C7.
Communication
CW(PM) – November 1, 2023
Item No. 4

RE: Committee of the Whole (Public Meeting)
Weston and 7 Secondary Plan
City File No. 26.2
SmartCentres Comments

**RE: Weston and 7 Secondary Plan
Transportation Master Plan Landowners Group Meeting
SmartCentres Comments**

RE: Weston and 7 Secondary Plan – Landowners Meeting and Phase II Project Update

Figure 2 – Northeast Quadrant

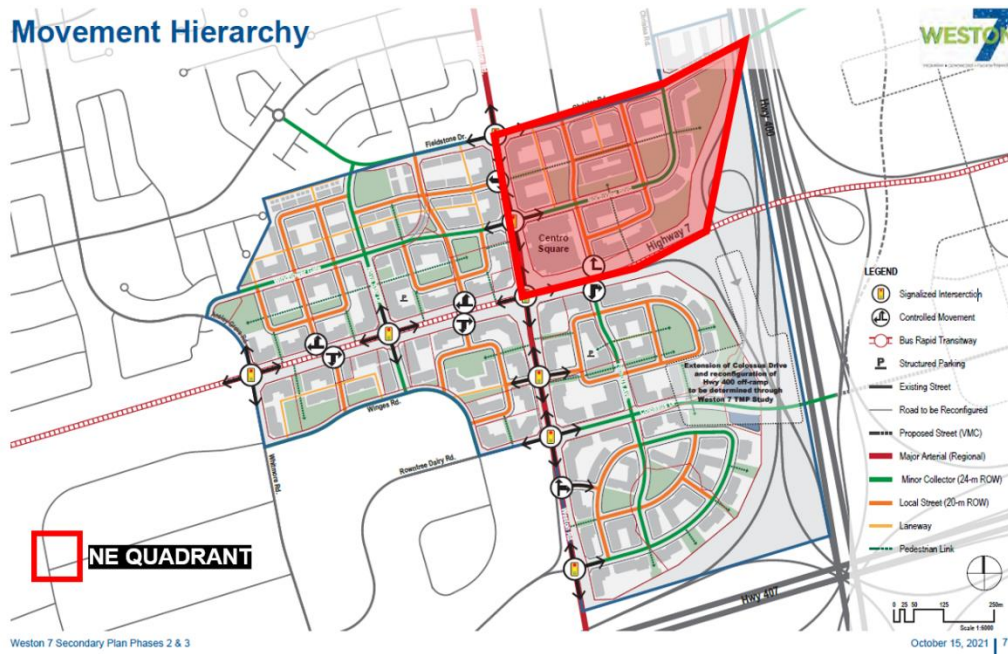
The project team’s plan (see **Figure 2**) has deleted two of the private streets SmartCentres designed and planned for by way of Official Plan Amendment Application no. OP.19.012 (i.e., the east-west link to Northview known as “Private Street 1” and the north-south link to Northview known as “Private Street 2”).

From a high level, the proposed street network layout results in remnant / irregular parcels of land, which do not contemplate nor appreciate the significant ~8m grade change along the recently re-constructed Highway 7, and the similar grade change along the Highway 400 off-ramp (see **Figure 3**). It is clear from the proposed street network (and by common-sense) that this is not an optimal location for an open space, and the project team should better coordinate with both SmartCentres and the MTO on this. Further, from a transportation perspective, the proposed street network results in very irregular / inefficient underground parking layouts, creating a sub-optimal condition from both an architectural and transportation perspective.

The transportation Update mostly disregards these design principles with the proposed street network size / layout, and we respectfully request that further discussions be undertaken with the project team to review and coordinate the Transportation Master Plan with our proposed Master Plan in relation to road patterns, street hierarchy, open spaces, etc.

Figure 4 – Northwest Quadrant

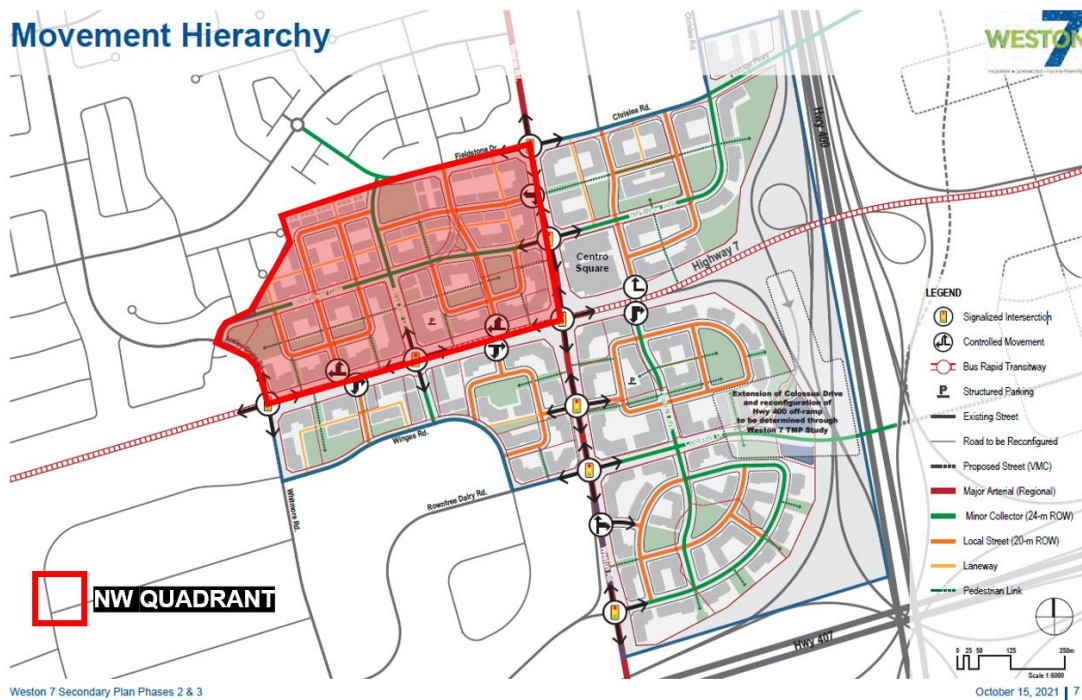
Although this quadrant is less developed from a formal planning application perspective, we are concerned about core urban design principles, such as the over-reliance on vehicular traffic, within our blocks. There seems to have been no regard nor consultation of created a pedestrian-oriented and environmentally friendly block layout, in keeping with the City of Vaughan's Official Plan policies. Additionally, similar to our above comments, these irregular block layout (by way of the proposed street network) will create extremely inefficient underground parking layout.

The road network and the resulting development framework has little regard for existing property boundaries and SmartCentres would need to review and ensure there are proper cost sharing mechanisms, so the burden of providing this infrastructure should not be entirely place on SmartCentres.

Figure 2 – Northeast Quadrant

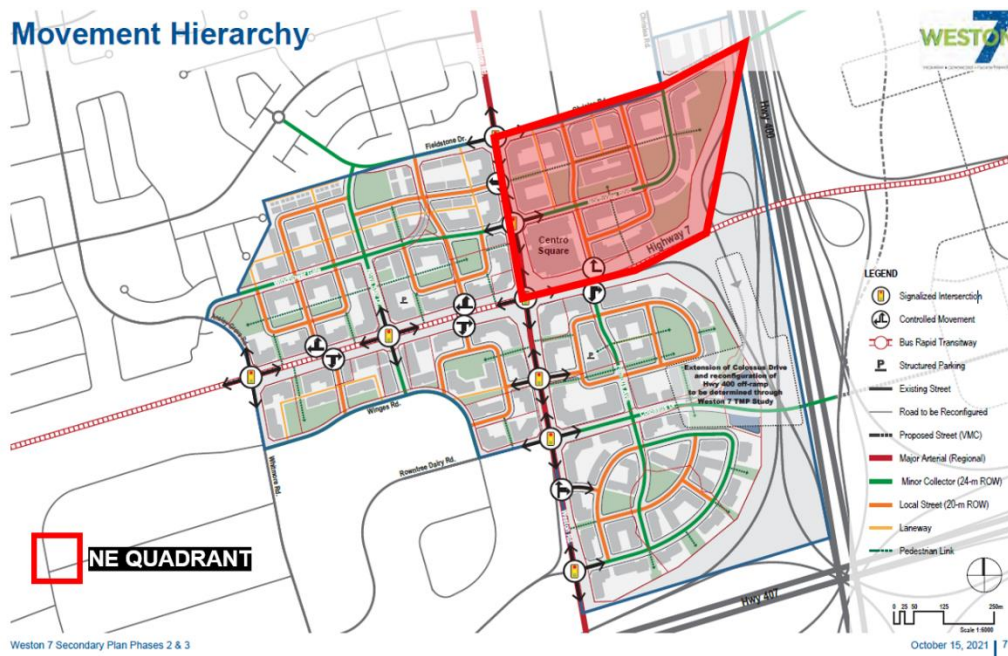
The project team’s plan (see **Figure 2**) has deleted two of the private streets SmartCentres designed and planned for by way of Official Plan Amendment Application no. OP.19.012 (i.e., the east-west link to Northview known as “Private Street 1” and the north-south link to Northview known as “Private Street 2”).

From a high level, the proposed street network layout results in remnant / irregular parcels of land, which do not contemplate nor appreciate the significant ~8m grade change along the recently re-constructed Highway 7, and the similar grade change along the Highway 400 off-ramp (see **Figure 3**). It is clear from the proposed street network (and by common-sense) that this is not an optimal location for an open space, and the project team should better coordinate with both SmartCentres and the MTO on this. Further, from a transportation perspective, the proposed street network results in very irregular / inefficient underground parking layouts, creating a sub-optimal condition from both an architectural and transportation perspective.

The transportation Update mostly disregards these design principles with the proposed street network size / layout, and we respectfully request that further discussions be undertaken with the project team to review and coordinate the Transportation Master Plan with our proposed Master Plan in relation to road patterns, street hierarchy, open spaces, etc.

Figure 4 – Northwest Quadrant

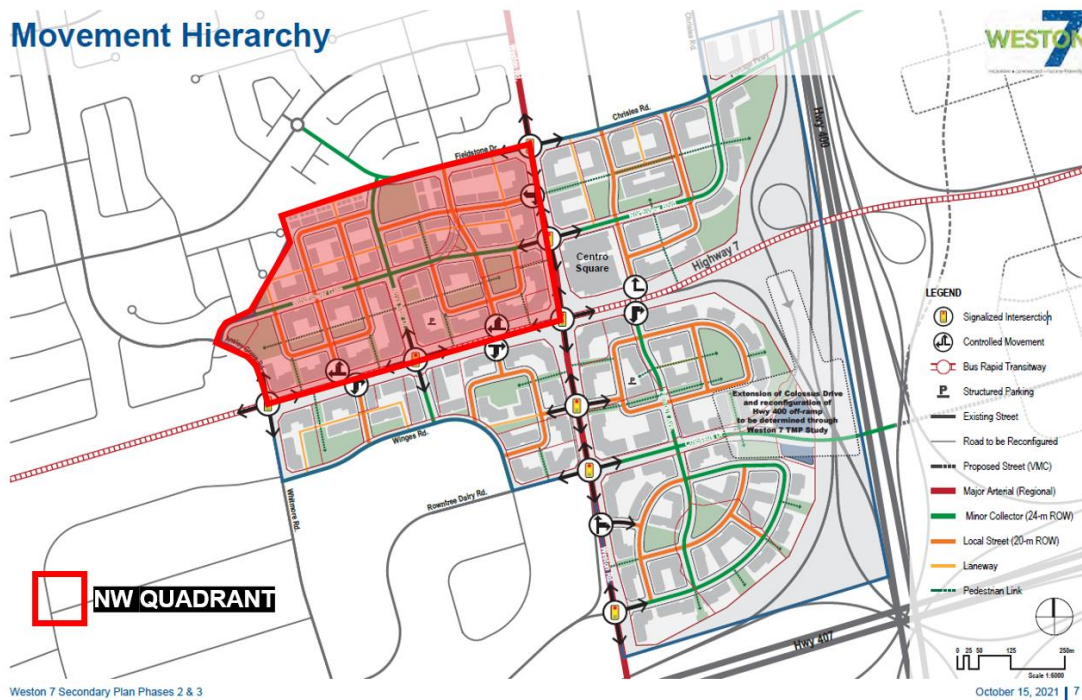
Although this quadrant is less developed from a formal planning application perspective, we are concerned about core urban design principles, such as the over-reliance on vehicular traffic, within our blocks. There seems to have been no regard nor consultation of created a pedestrian-oriented and environmentally friendly block layout, in keeping with the City of Vaughan's Official Plan policies. Additionally, similar to our above comments, these irregular block layout (by way of the proposed street network) will create extremely inefficient underground parking layout.

The road network and the resulting development framework has little regard for existing property boundaries and SmartCentres would need to review and ensure there are proper cost sharing mechanisms, so the burden of providing this infrastructure should not be entirely place on SmartCentres.
